ALERT SERVICE BULLETIN

UH-1H-16-17
PSL 700000201
21 December 2016

SUBJECT: TAIL ROTOR YOKE 204-011-722-005 CHROMATE CONVERSION COATING

Figure 1. Conversion Coating Application Areas

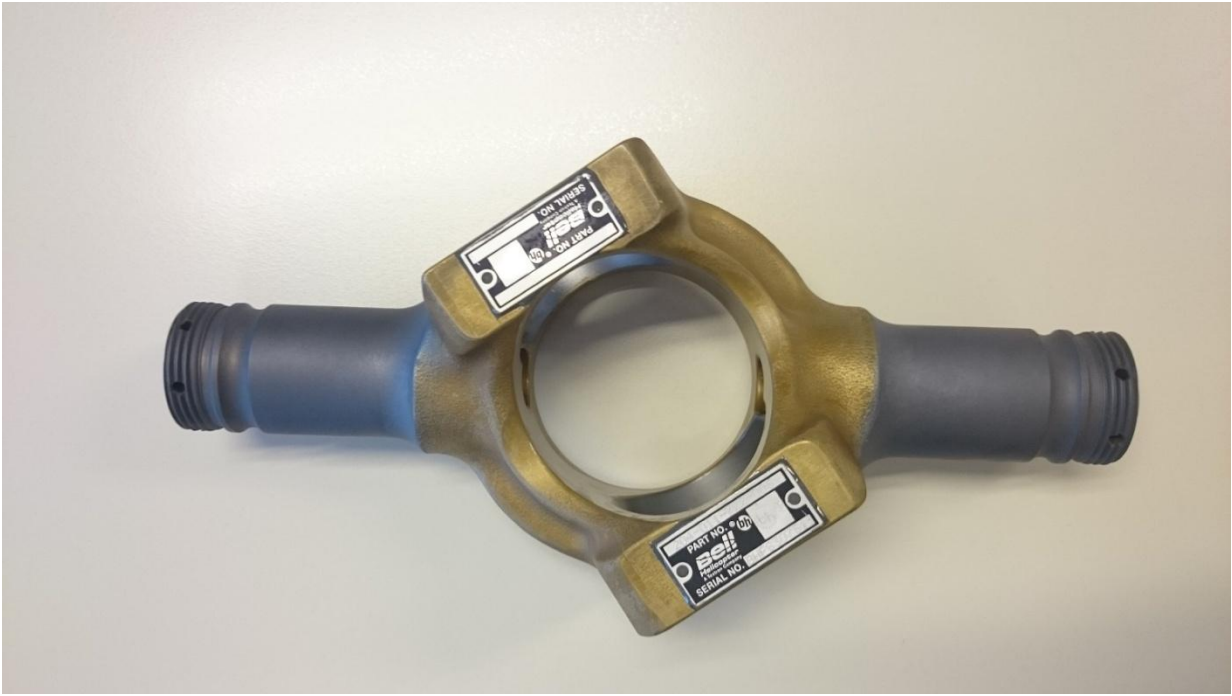
7. Apply the chromate conversion coating (BHT-ALL-SPM, Chapter 3, Paragraph 3-18). Do not apply the chromate conversion coating in the trunnion bores or on the yoke spindles. For an example of the chromate conversion-coated areas, refer to Figures 1 and 2.
8. Once the chromate conversion coating has been reapplied successfully, the tail rotor hub and blade can be reassembled (TM 55-1520-210-23-1, Chapter 5).
9. Make an entry in the helicopter and component historical service records to indicate that **Part II** of this bulletin has been accomplished as a terminating action to this bulletin.
